Access Compliance Report

Public Rights-of-Way (Curb Ramps)

Intersection ID: 49272	Main Street: GIBBONS_LINK_RD	Cross Street: TOMSIE_EFIRD_LN	Location: NW
ADA ID: ABB70518052F	Ramp Type: Perp	Initial Pass/Fail: Fail	Overall Compliance: No
Severity Score: 26.25			
Codes/Mitigation Info/Possible Solution		Field Measurements/Component Compliance

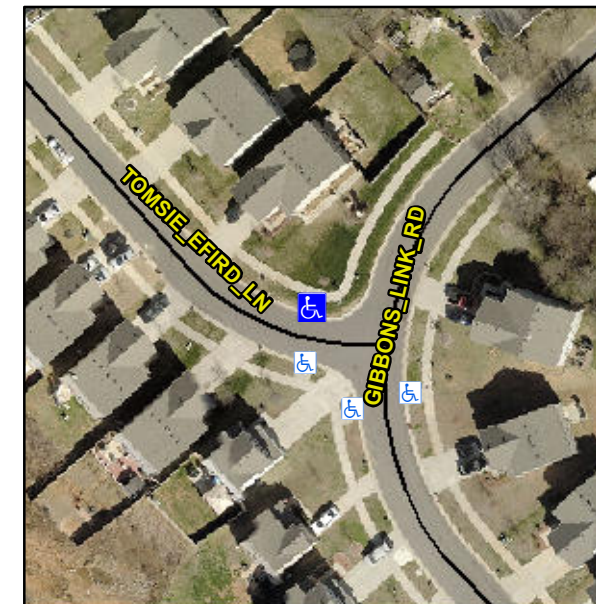
Remove & Replace Entire Ramp.

R304.2.2, R304.5.3

Compliance	Description	Data	Compliance	Description	Data
N/A	Ramp Length (in)	55.0	No	Ramp Slope (%)	15.2
Yes	Ramp Width (in)	49.0	No	Ramp XSlope (%)	4.4
N/A	Flare Type LT	N/A	N/A	Flare Type RT	N/A
N/A	Flare Slope LT (%)	N/A	N/A	Flare Slope RT (%)	N/A
N/A	Flare Traversable LT?	N/A	N/A	Flare Traversable RT?	N/A
N/A	Landing Length (in)	N/A	N/A	DWS Provided?	N/A
N/A	Landing Width (in)	N/A	N/A	DWS Contrast?	N/A
N/A	Landing Slope (%)	N/A	N/A	DWS Length (in)	N/A
N/A	Landing X Slope (%)	N/A	N/A	DWS Full Width?	N/A
N/A	Landing Curb? (Y/N)	N/A	N/A	DWS Offset (in)	N/A
N/A	Shared Landing?	N/A			
N/A	Gutter Ponding?	N/A	N/A	Gutter Slope (%)	N/A
N/A	Gutter Lip Ht (in)	N/A	N/A	Gutter X Slope (%)	N/A
N/A	Painted X Walk1?	No	N/A	Painted X Walk2?	N/A
	X Walk 1 Direction	To S		X Walk 2 Direction	N/A
N/A	X Walk 1 Width (in)	N/A	N/A	X Walk 2 Width (in)	N/A
	X Walk 1 Slope (%)	4.0		X Walk 2 Slope (%)	N/A
	X Walk 1 X Slope (%)	4.3		X Walk 2 X Slope (%)	N/A
